## **ZONING CHANGE REVIEW SHEET**

**CASE:** C814-2017-0001 – 425 W. Riverside PUD

**ADDRESS:** 425 W. Riverside Drive

**ZONING FROM:** CS-1-V-NP      **TO:** PUD-NP

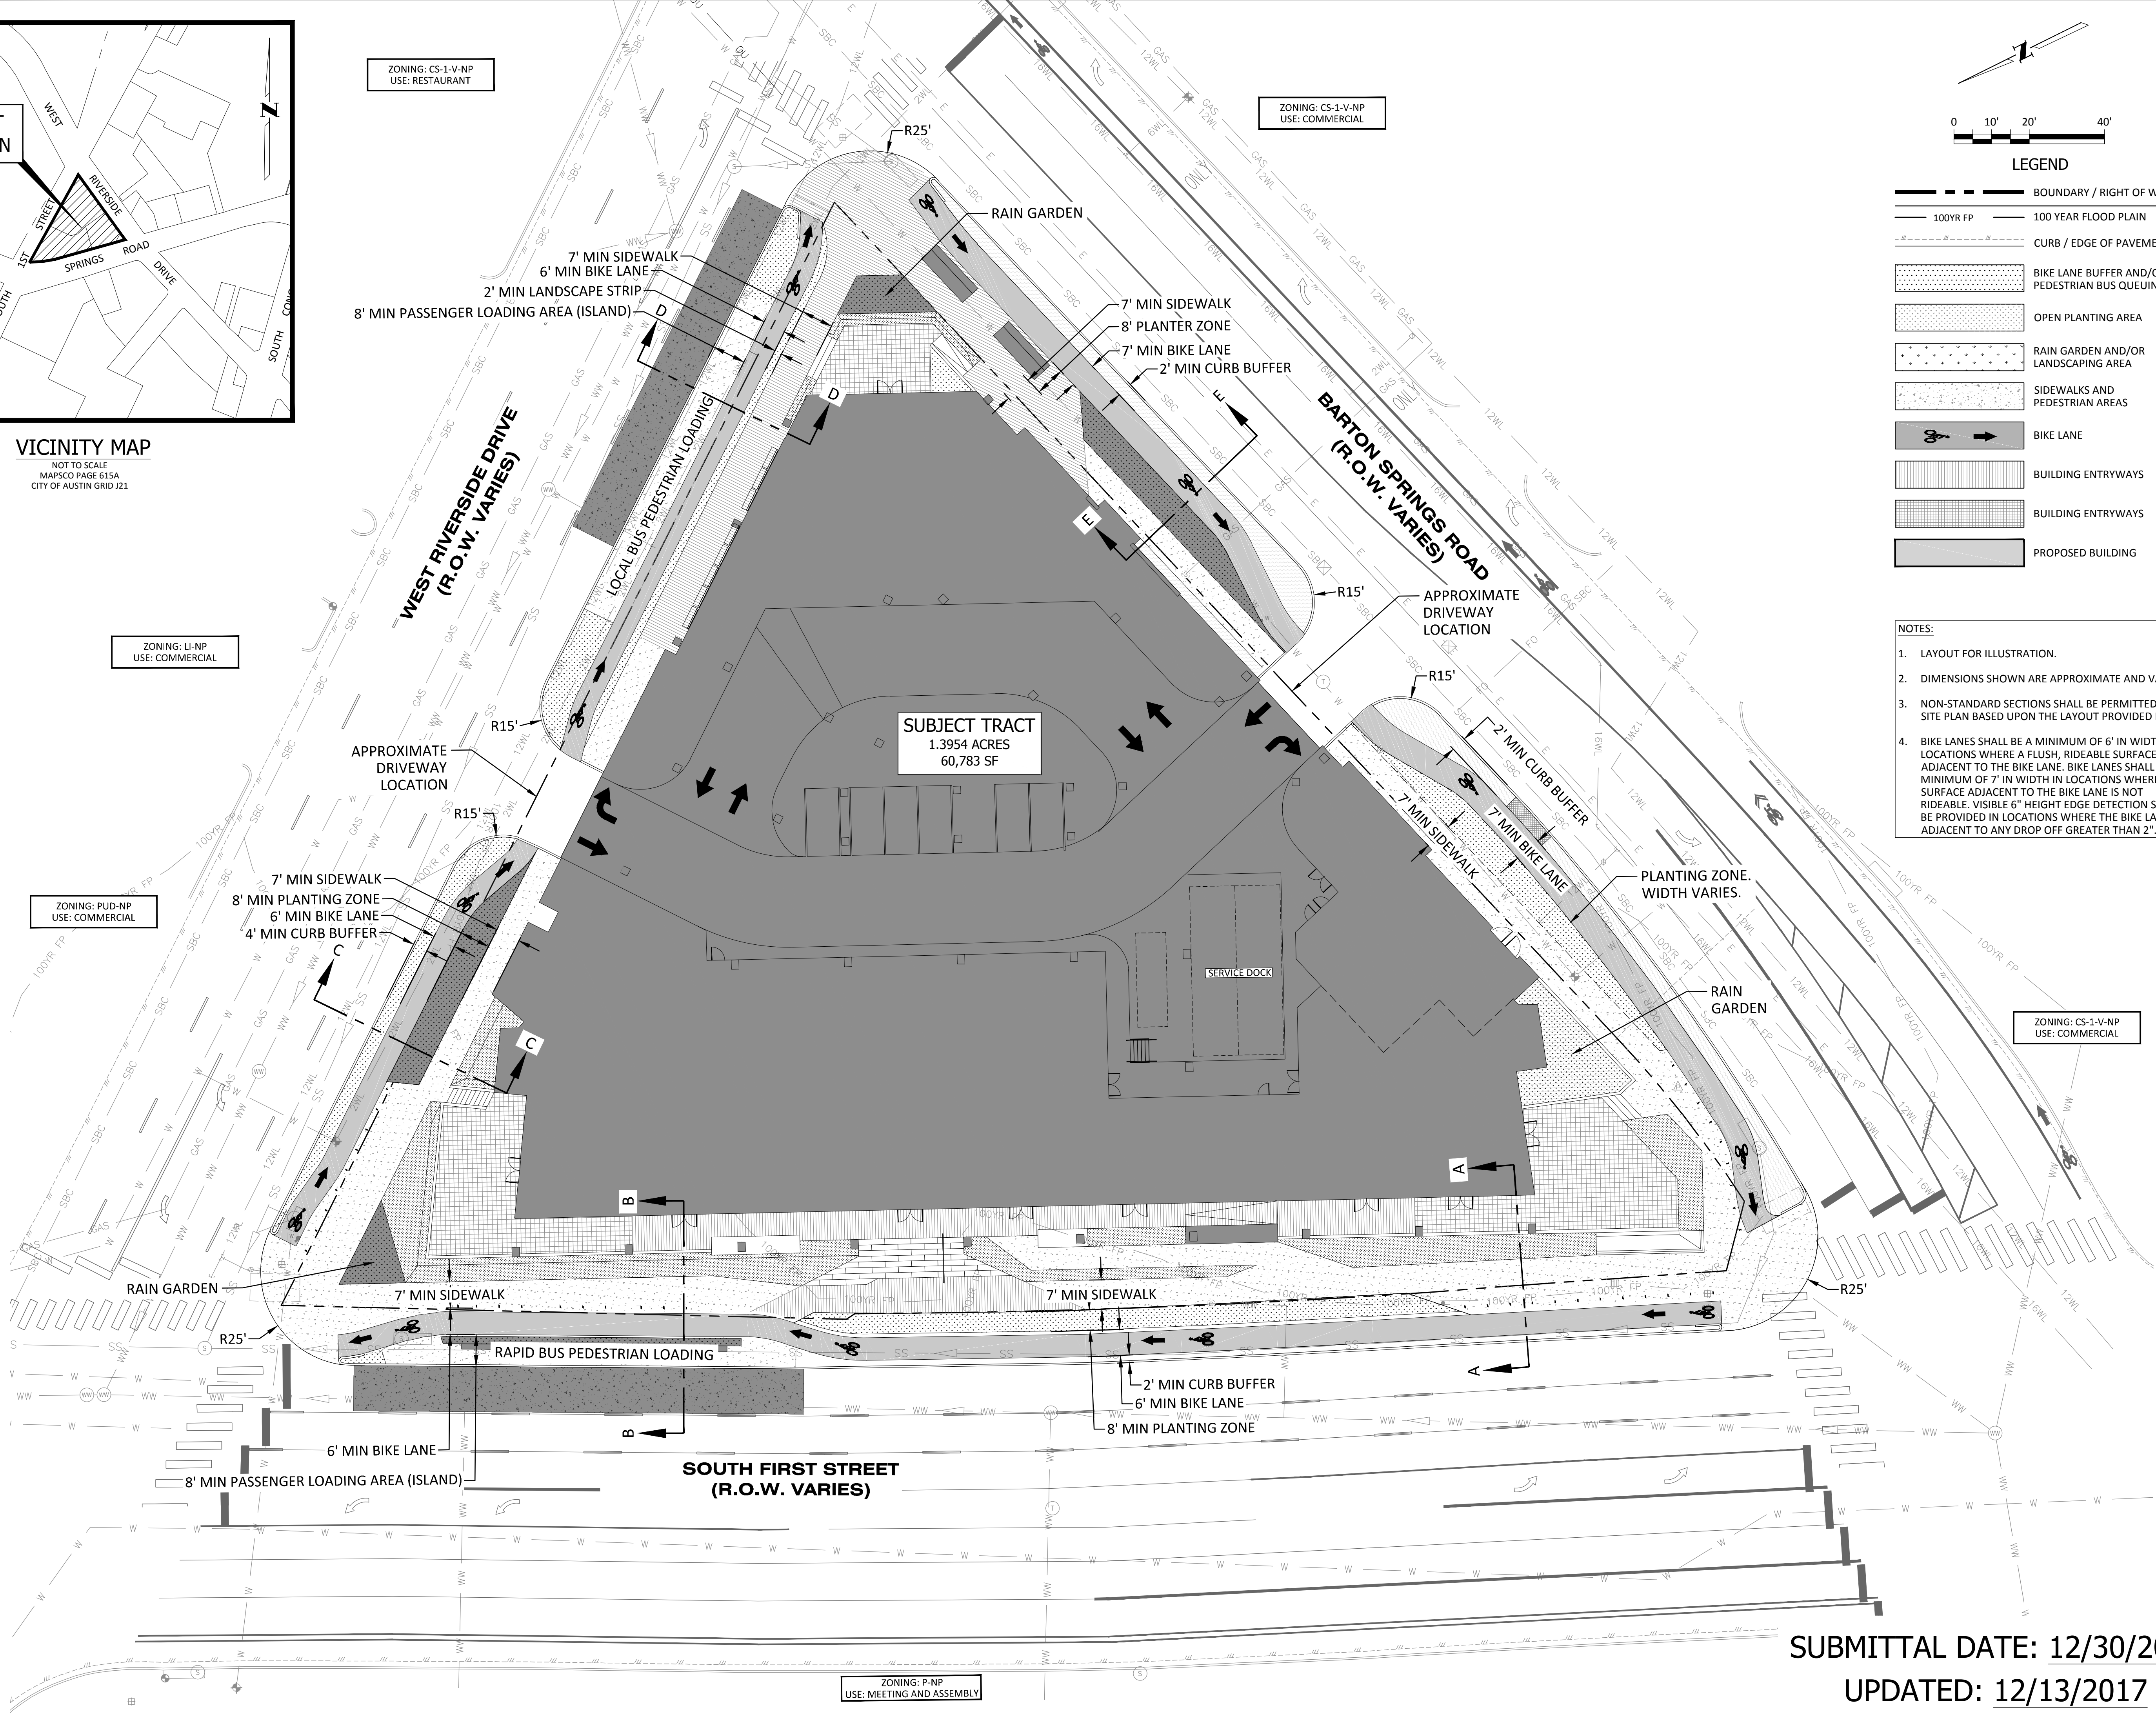
- #1 Corner radiuses: I’m OK with the 25’ radius representation on the land use plan – Exhibit C under the assumption that these show effective radiuses and that details of ADA ramp and bikeway configurations and actual curb radiuses will be decided at site plan (while conforming to the effective radius.

- #2 On exhibit C, note 4 should be removed. In the above comment we need to retain the ability to design the corners and bikeway interactions at site plan. A single curb ramp is not preferred from an pedestrian / bicycle design and may not align with ADA requirement / best practices.

- #3 Bicycle Lane Width - the bicycle lane widths do not conform to the original drawing I sent in May. In the attached Exhibit C and E I have marked up width changes. In short the following are the dimensional requirements for the bicycle lane in a few scenarios:  
If pavement on either side of bicycle lane is not rideable than 7' is the minimum bikeway dimension.

If there is a dropoff into a rain garden there needs to be a hand rail that is recessed from the bike lane by 6" as to not encroach in the bicycle lane space (handrails should be added to relevant cross sections in exhibit E. If there is rideable pavement on both sides of the bike lane the minimum acceptable dimension is 6'
